Executive Director's Recommendation

Commission Meeting: July 7, 2016

PROJECT National Museum of Natural History - South Entrance Renovation 1000 Constitution Avenue, NW, Washington, DC	NCPC FILE NUMBER 7753
SUBMITTED BY Smithsonian Institution	NCPC MAP FILE NUMBER 1.24(38.00)44370
REVIEW AUTHORITY Federal Projects in the District per 40 U.S.C. § 8722(b)(1) and (d)	APPLICANT'S REQUEST Approval of comments on concept design
	PROPOSED ACTION Approve comments as requested
	ACTION ITEM TYPE Consent Calendar

SYMMETRICAL SWITCHBACK

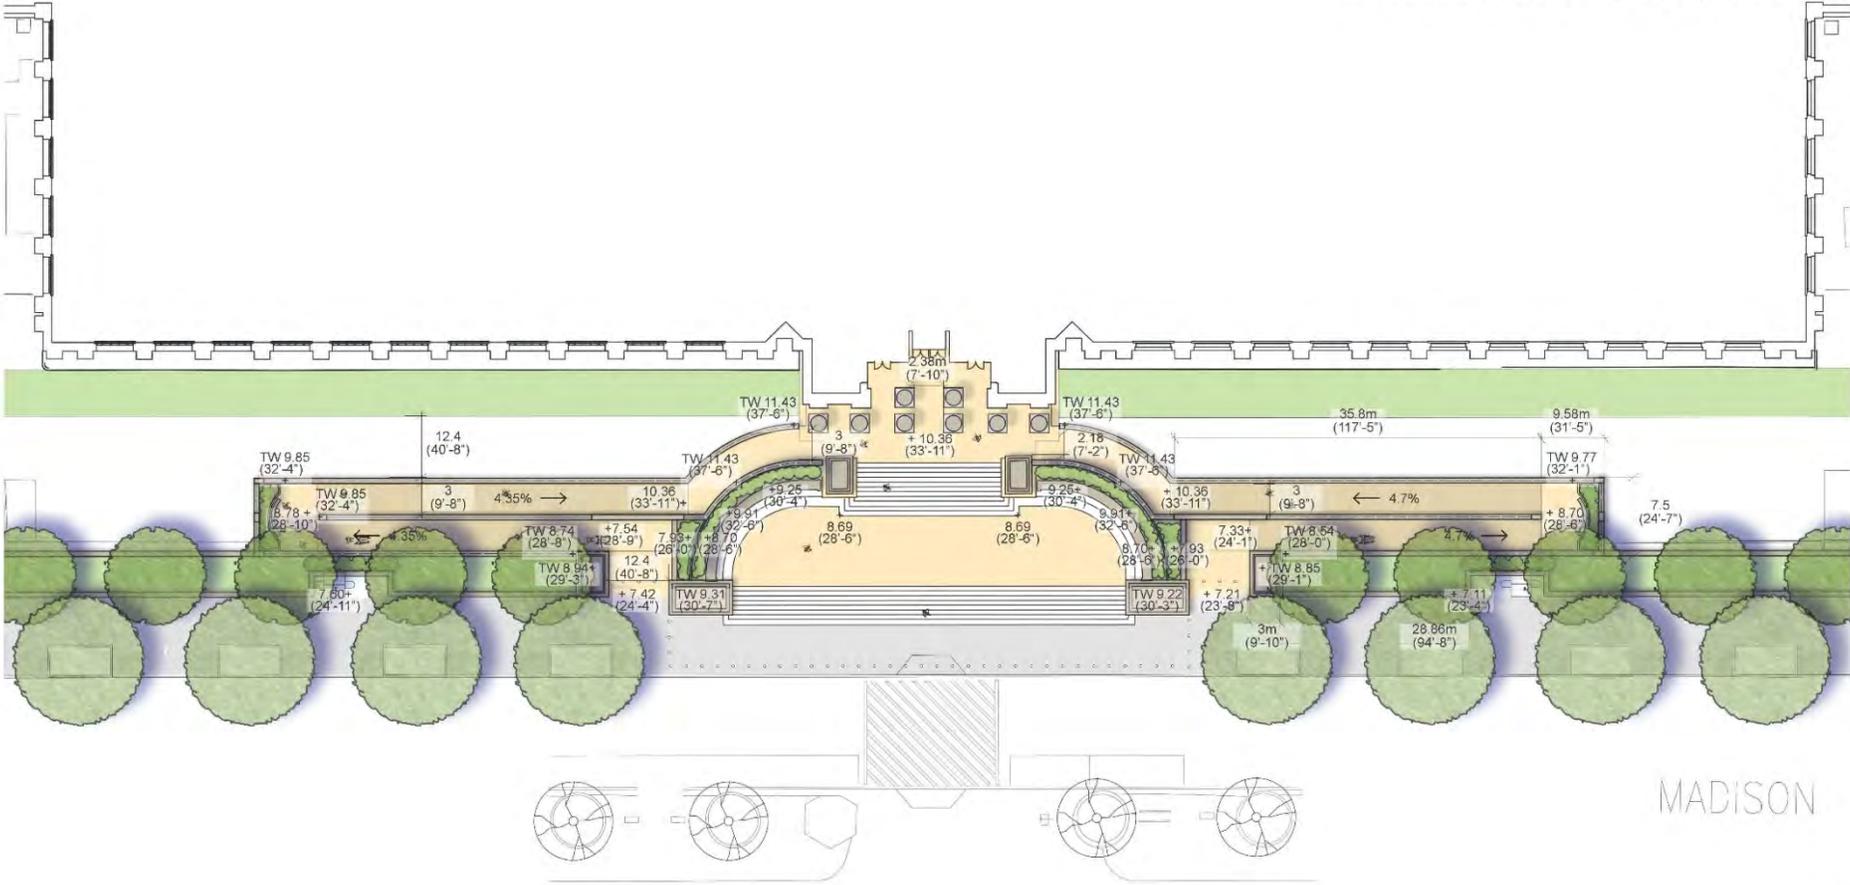
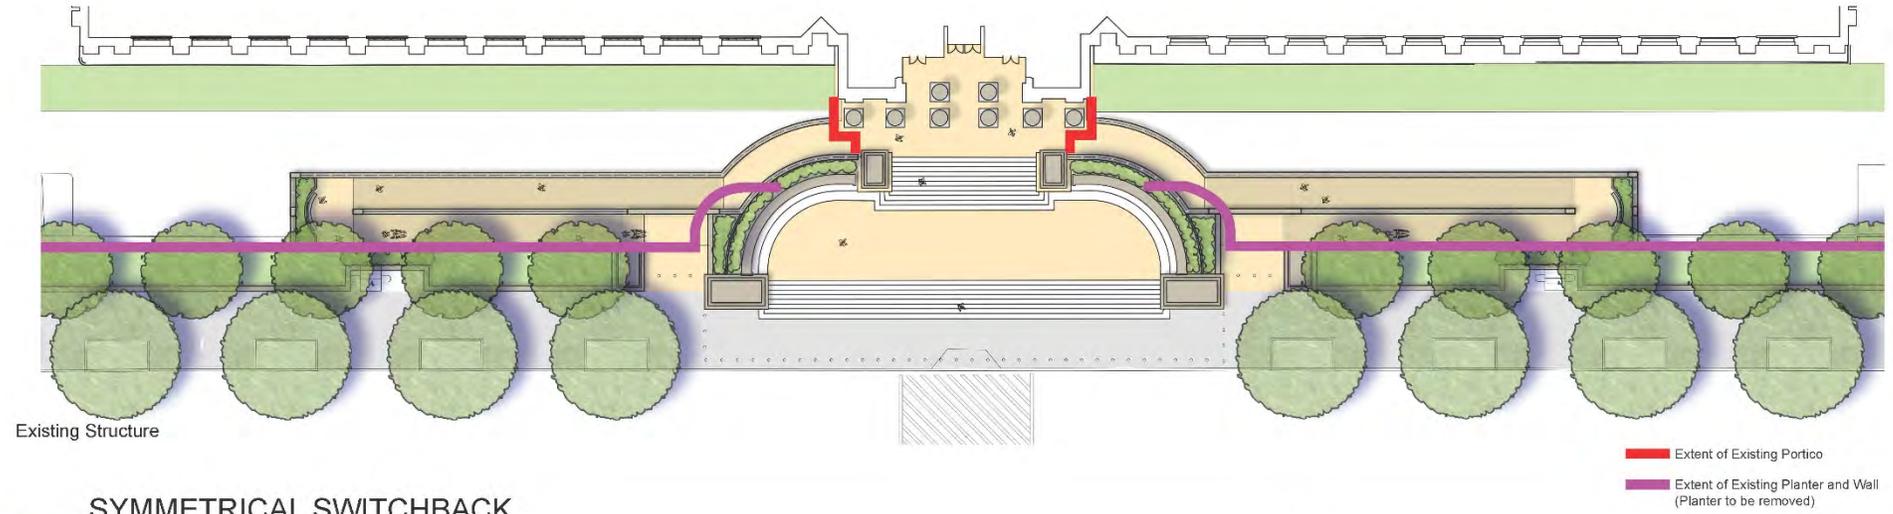
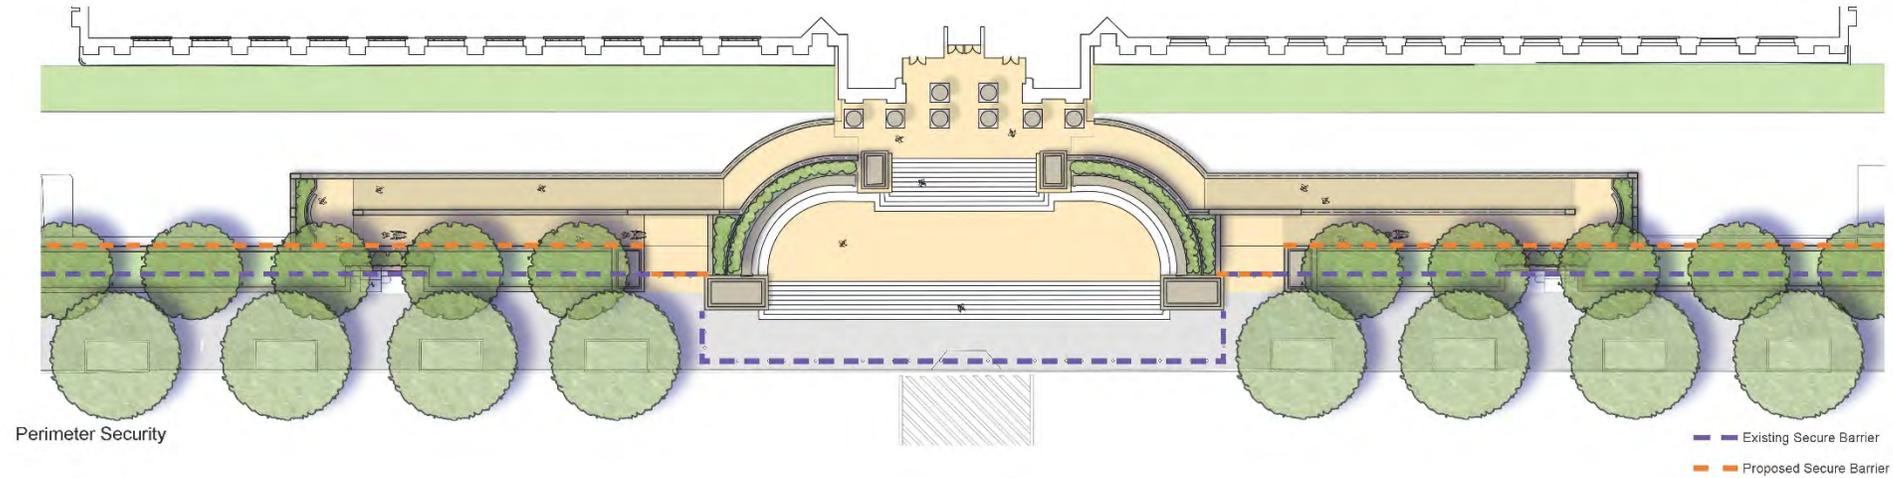
Supports the preferred concept for a symmetrical switchback walkway at the south entrance of the National Museum of Natural History.

The building is a contributing element to the National Mall Historic District. The south portico and entry stairs are character-defining features of the building, and in order to avoid adverse effects to these elements, several options for an accessible walk were considered. Alternatives included an asymmetrical approach with one ramp on the west with a steeper incline and a switchback ramp on the east as well as a symmetrical curved ramp. Both of these alternatives would alter the character of the portico to a greater degree with the addition of a large upper plaza than the proposed scheme of a symmetrical switchback walkway. In addition to the portico and entry stairs, the building is defined by its neoclassical architectural details and overall symmetry. A symmetrical switchback walkway has a compact footprint, responds to the architectural details of the existing building, and minimizes potential adverse effects to the character-defining portico and entry stairs. The scale of the upper plaza is reduced with the symmetrical switchback walkway, thereby reducing impacts on the portico. In addition, a planting bed will be added between the historic bench on the lower plaza and the new upper plaza so that there is a transition between the historic and new elements. Staff recommends that the Commission support the Smithsonian's preferred concept for a symmetrical switchback walkway at the south entrance.

TYPICAL WALKWAY SECTIONS

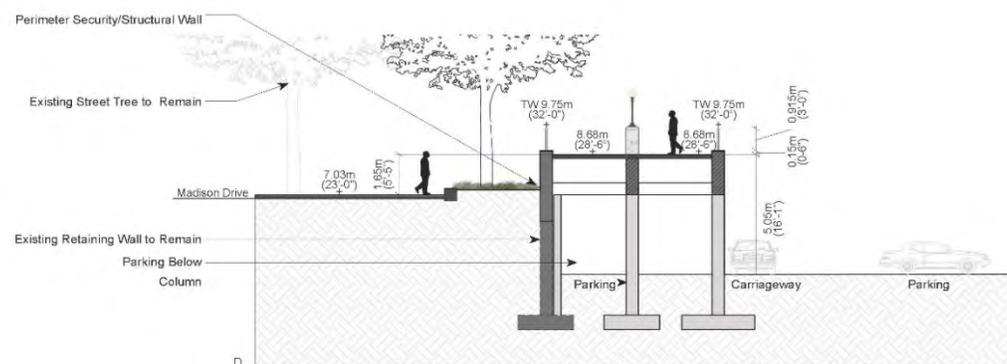
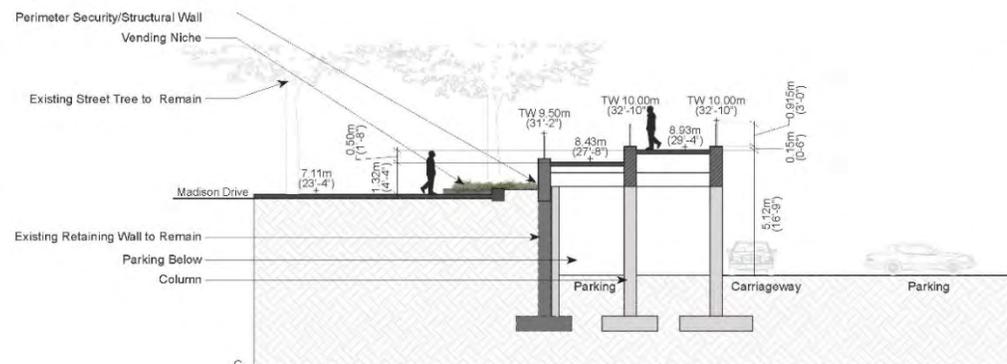
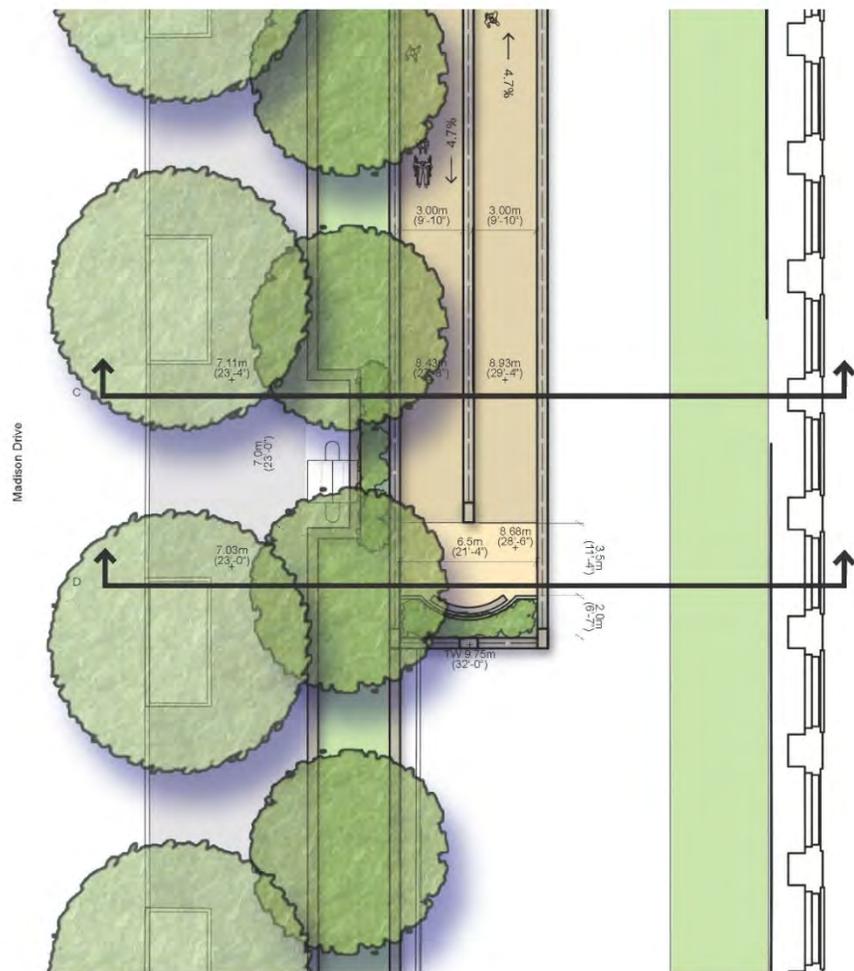
Recommends the Smithsonian Institution explore additional design solutions for the feature wall at the base of the walkway to reduce its scale and mass, and improve visibility of the historic building.

At the base of the walkway, a feature wall just under 14-feet tall will include integrated signage. The feature wall will include a leather finish to distinguish it from the walkway walls. The height of the feature wall and its overall mass is out of scale with pedestrian environment. Staff is recommending the Smithsonian explore alternatives that break down the mass and scale of the wall. It may be preferable to lower the height of the feature wall and continue the railing across the top of the wall so that the walkway reads as one composition. Minimizing the height of the wall and continuing the railing would also increase the visibility of the historic building. Staff recommends that **the Commission comment that the Smithsonian explore additional design solutions for the feature wall to reduce its scale and mass, and improve visibility of the historic building.**
